PRODUCT ADVISORY

**Data Sheet Specification
Change for Intersil Products
ISL97682*, ISL97683*, and
ISL97684***

**Refer to:
PA12037**

Date: May 17, 2012

FIGURE 1. ISL97684 TYPICAL APPLICATION DIAGRAMS

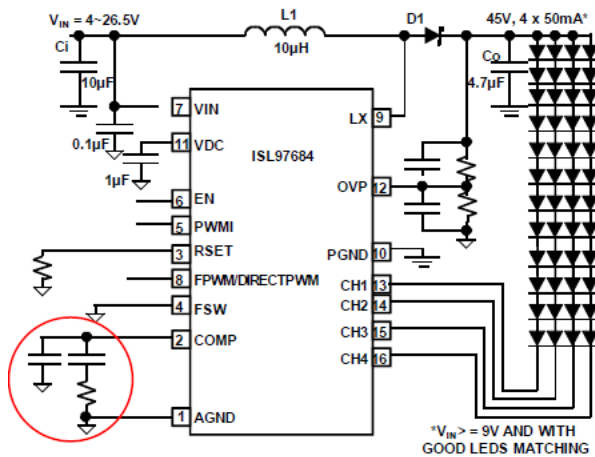
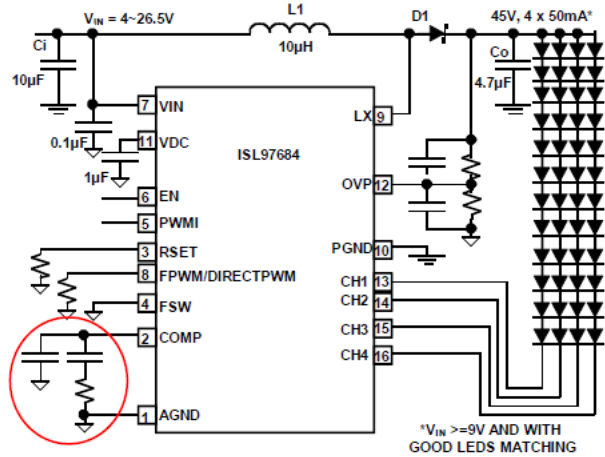
This advisory is to inform you that Intersil has changed the data sheet specification for the listed ISL97682*, ISL97683*, and ISL97684* products. The updates specify the resistor and capacitor values for the COMP pin in the *Figure 1 - Typical Application Diagrams* and change the FSW (Switching Frequency) voltage levels in the *Pin Descriptions* table and *Switching Frequency and PWM/PFM Mode* section of the data sheet. Details regarding the changes are contained on the following pages. The updated data sheet is available on the Intersil web site at <http://www.intersil.com/content/dam/Intersil/documents/fn76/fn7689.pdf>.

- Figure 1 - Typical Application Diagrams (Page 1):

Change From:

FIGURE 1. ISL97684 TYPICAL APPLICATION DIAGRAMS

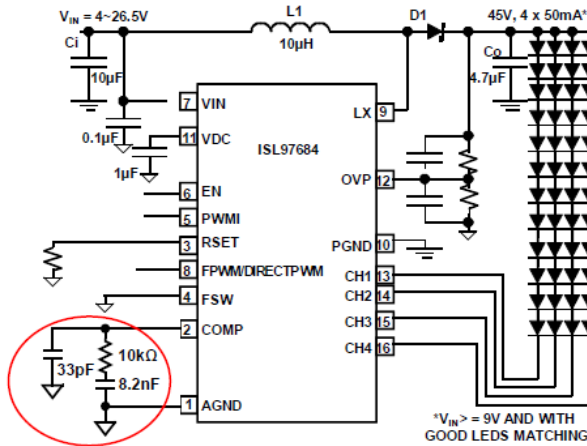
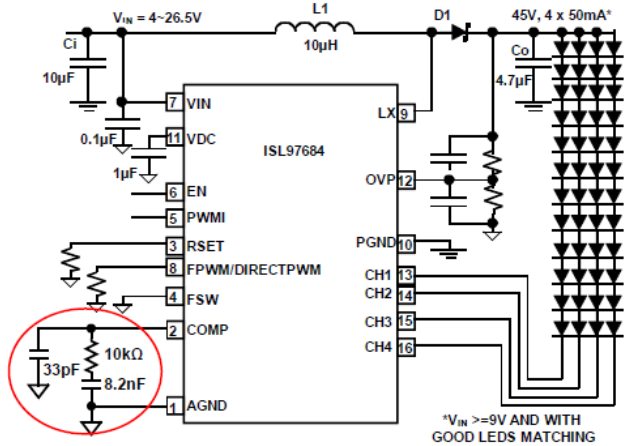
Change To:
